Network Apparels Ltd. (Extended Building)

4th August 2019

Observations

Internal columns are stressed above normal design limit considering prepared load plan

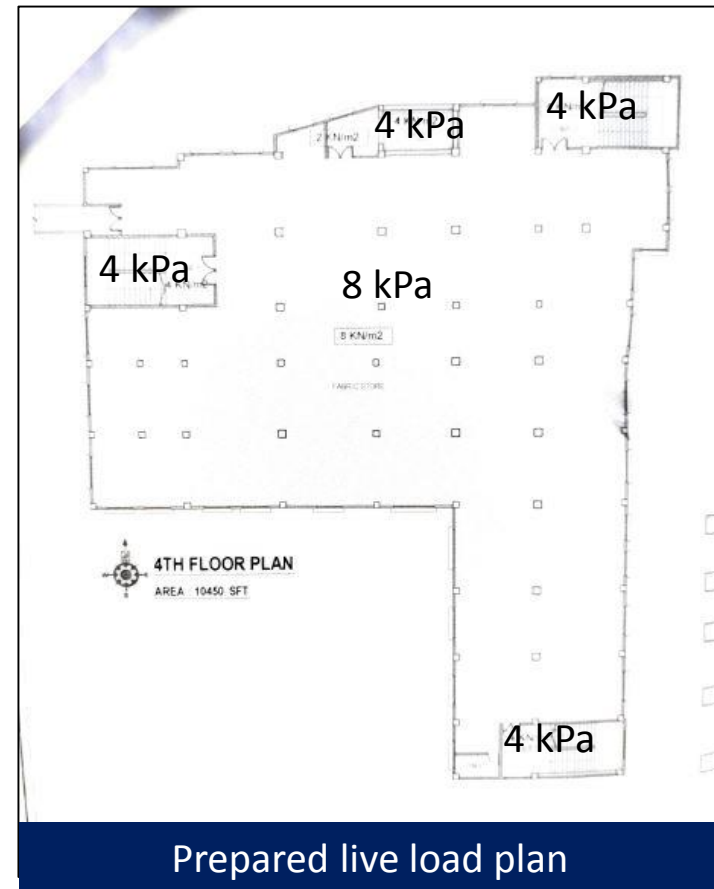
The prepared load plan indicates 2~4 kPa live load on general floor and 8 kPa on storage (2nd , 4th & 5th floor). Cursory calculation indicates the marked internal columns are stressed above normal design limit considering prepared live load plan. Building engineer is required to produce allowable load plan according to BNBC.

Item No.	Observation	Recommended Action Plan	Recommended Timeline
1	Internal columns are stressed above normal design limit considering prepared load plan	Maintain loading below 3 kPa until further review.	6-weeks
2	Internal columns are stressed above normal design limit considering prepared load plan	Factory Engineer to review design, loads and columns stresses in area identified above.	6-weeks
3	Internal columns are stressed above normal design limit considering prepared load plan	Verify in situ concrete stresses either by 100mm dia. Cores(Min. 4 nos) or existing cylinder strength data.	6-weeks
4	Internal columns are stressed above normal design limit considering prepared load plan	Produce and actively manage a loading plan for all floor plates within the factory giving consideration to floor capacity and column capacity. Also comply the loading according to BNBC.	6-weeks
5	Internal columns are stressed above normal design limit considering prepared load plan	Carry out remedial works arise from Engineering Assessment where necessary.	6-months

Apparently non engineered roof

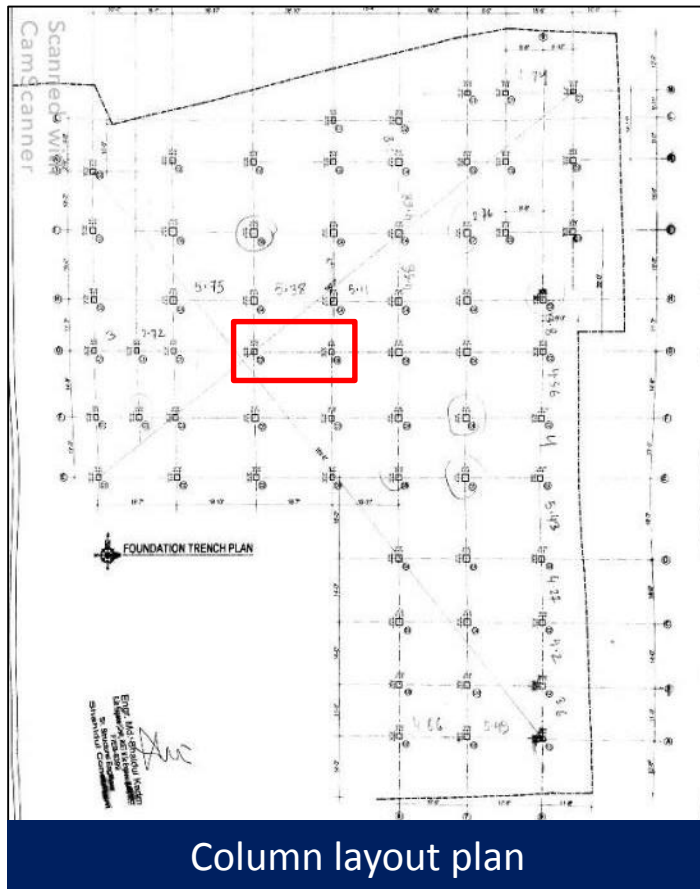
- Apparently inadequate roof framing.
 - Poor connection details.
- Building engineer is required to check the connection and member adequacy against the uplift forces.

Steel frame rest on masonry wall without adequately anchored.

6	Apparently non engineered roof	Building engineer is required to check the connection and member adequacy against the uplift forces.	6-weeks
7	Apparently non engineered roof	Carry out any repair work according to suggestion of building engineer or make any alteration works suggest by building engineer.	6-months
